SERVICE BULLETIN

M-998

SAFETY RECALL CODE 070

1990 XLH MODELS POSITIVE BATTERY CABLE WIRE FORM

Figure 1. Wire Form Correct and Incorrect Identification

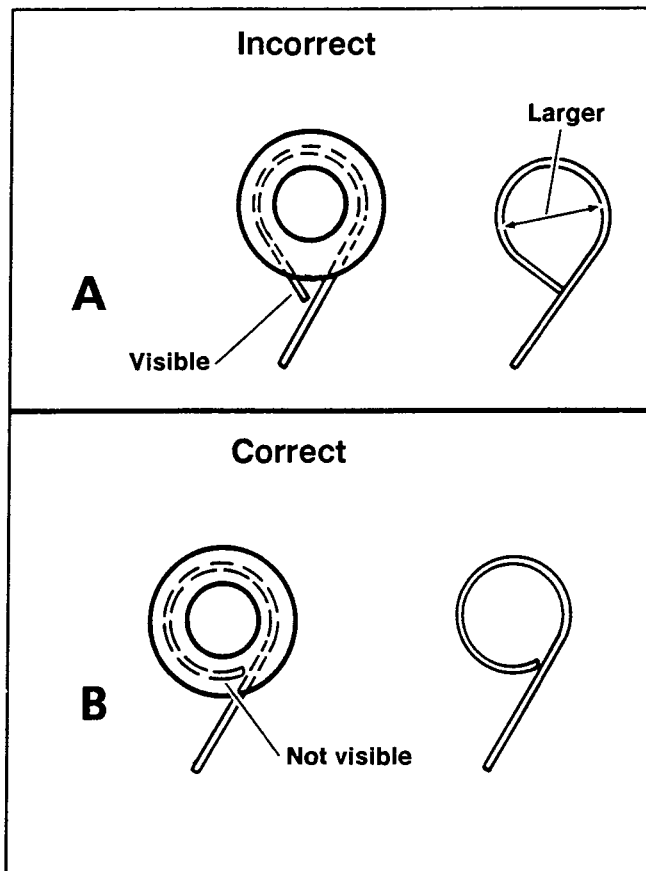
Harley-Davidson, Inc. has become aware that some 1990 XL model motorcycles may have been assembled with wire forms not meeting specifications. These wire forms secure rubber grommets which serve as a routing guide for the positive battery cable. Theoretically, the possibility exists these wire forms could chafe the positive battery cable causing a short circuit to the motorcycle chassis. If this occurs, the battery cable might overheat, possibly to a degree which might cause a vehicle fire.

the wire form from in front of the battery. The end of the wire, on the incorrect wire form extends below the perimeter of the grommet and is visible as shown in view "A". The correct wire form makes a full circle, the end follows the curvature around the groove in the grommet and is not visible as shown in view "B".

If the inspected vehicle is found to have an incorrect wire form, perform the replacement procedure outlined below.
